Product Change Notification

Change Notification #: 113715 - 00
Change Title: Intel® Server System R2312GZ4GC4,
PCN 113715-00, Product Design,
Update Resistors and Capacitor
Date of Publication: March 16, 2015

Intel is implementing the following change on the Intel® Server System R2312GZ4GC4:

Figure One. Component Locations for the 2U Riser Spare A2UL8RISER

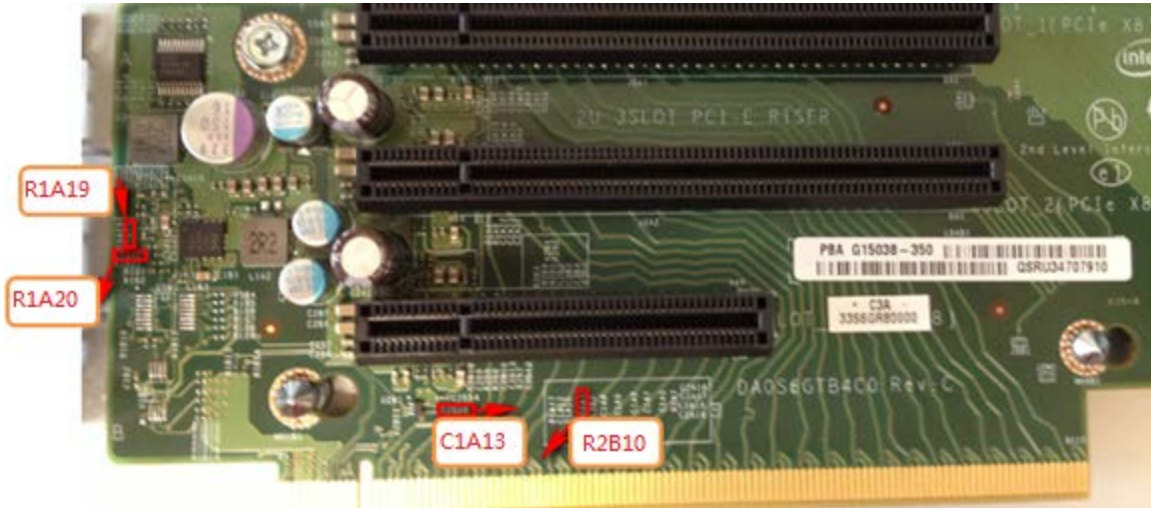
- Update the following resistors and capacitor (see Table One and Figure Five) on the 2U PCIe Riser Spare A2UL8RISER to make an improvement to support a higher 3.3 Voltage Regulator startup over current. Before this change, the Voltage Regulator on the riser card may not be able to turn on when the total current drawn is more than 5A current. After this change, the Voltage Regulator on the riser card can support more than 10A current.

Component	Location	Pre-change	Post-change
Resistor	R2B10	10.00 kOhm	3.65 kOhm
Resistor	R1A20	0 Ohm	30 Ohm
Resistor	R1A19	40.20 kOhm	20.00 kOhm
Capacitor	C1A13	10.00 pF	120.00 pF
